RE: DA-1250-58 Response to Comments

Atwell Project Number: 21003852

Please see below for Atwell's response to comments provided by Aurora Planning and Development Services on June 5, 2024. This is in regards to the proposed Flatrock Trail development, also known as DA-1250-58.

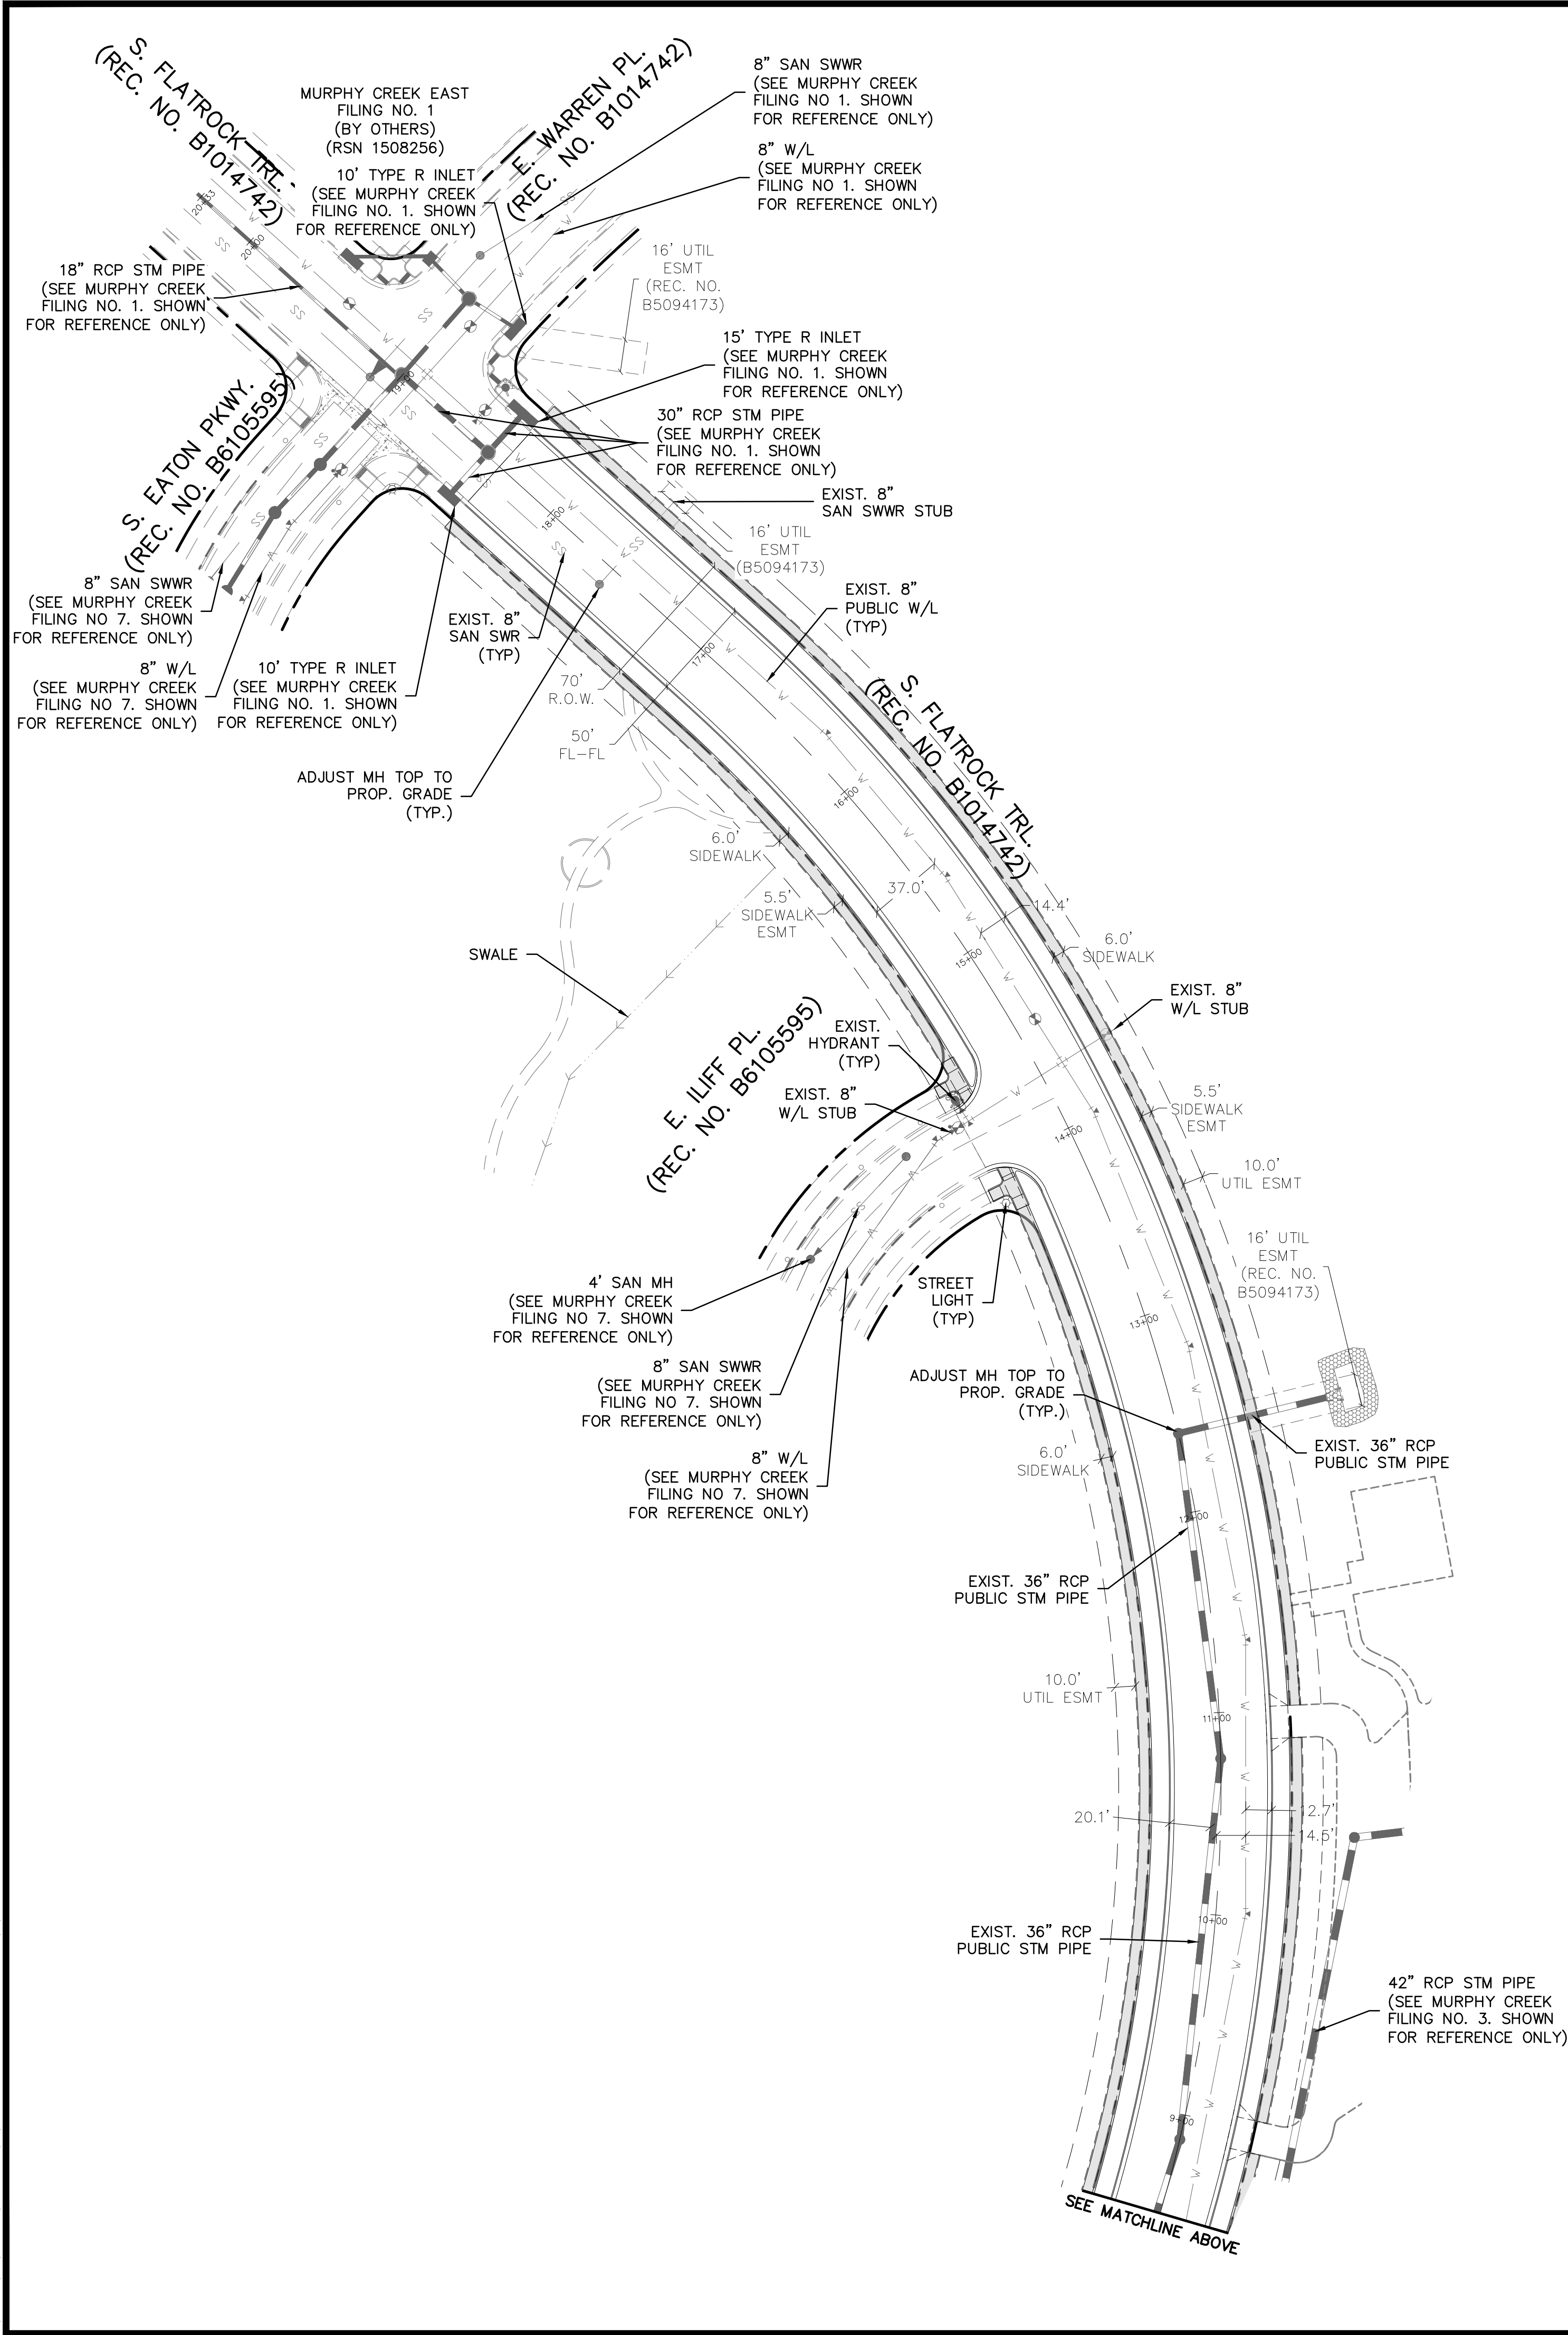
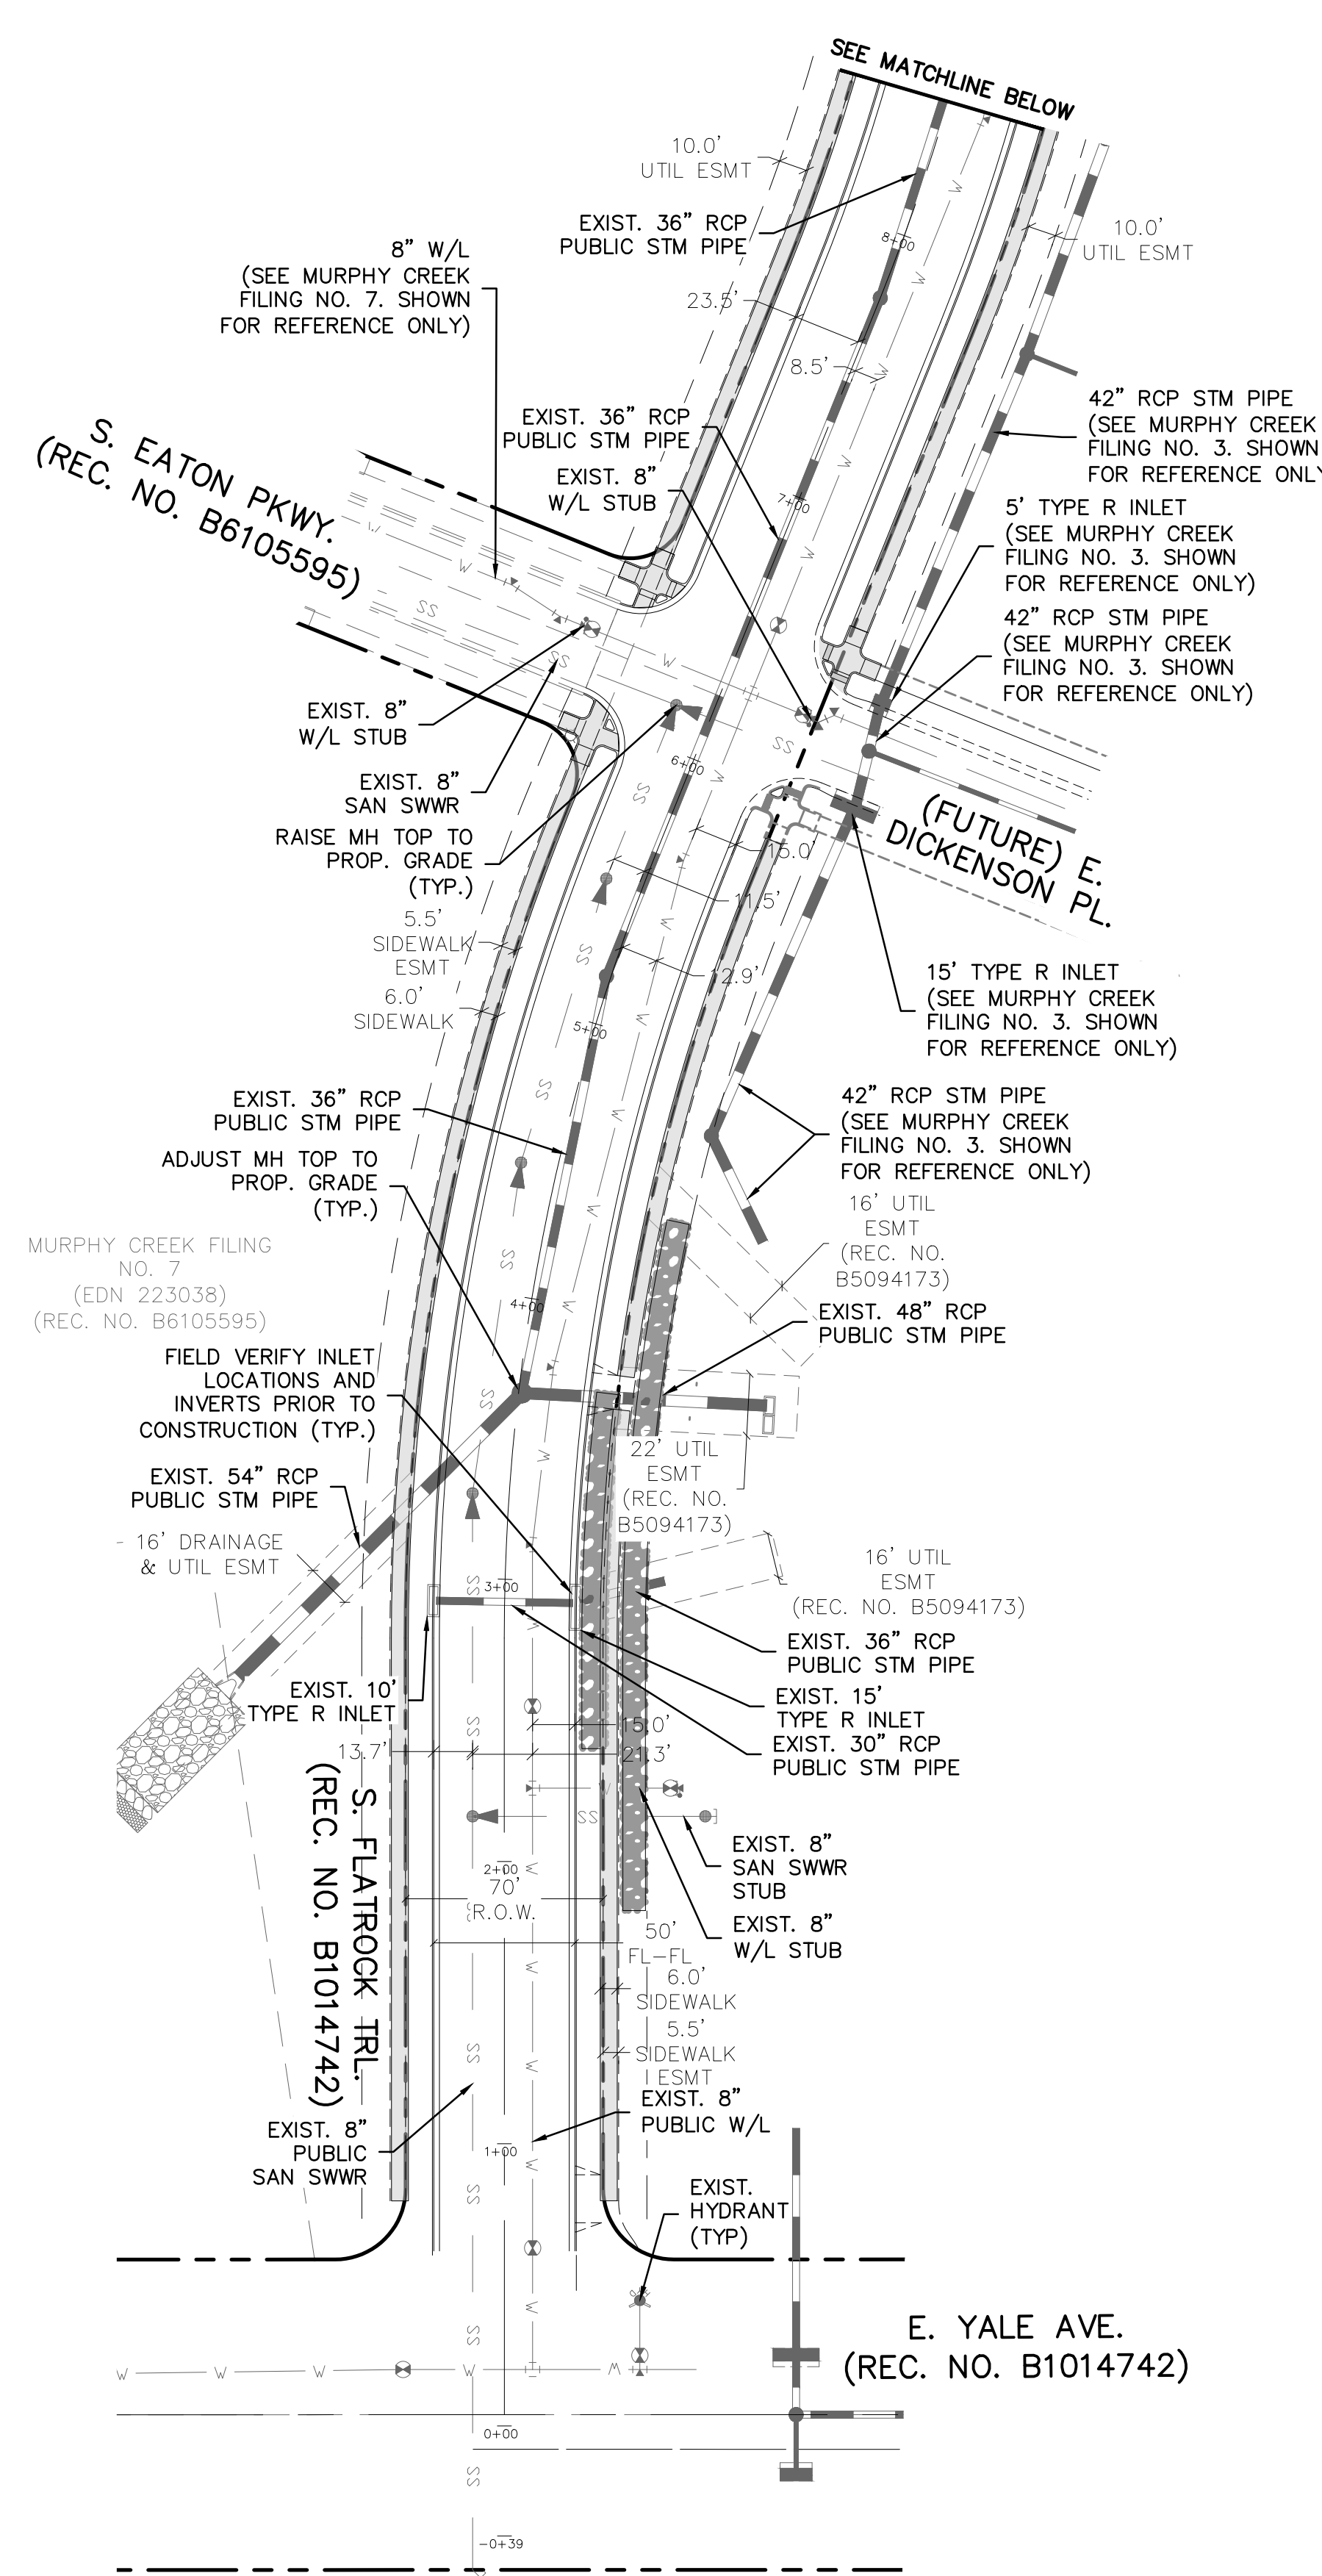
4A. Verify if we need signs 1 & 2.

4B. Remove leader where identified. [2 comments]

4C. Based on the traffic study the E Yale Ave intersection will be a Roundabout.

4D. Previous Comment was not fully addressed: In anticipation for roundabout, need to end bike lane and provide a way for bikes to exit road.

4E. Move identified light to the other side of the street light.

Response: Signs are within scope of Murphy Creek East Filing 3 plans.

Response: Leader removed.

Response: Per discussion with Aurora, a T-intersection will be designed for this intersection..

Response: Per discussion with Aurora, a T-intersection will be designed for this intersection. Bicycles will exit the road and use the proposed 14' walk/bike lane along Yale.

Response: Street light moved.
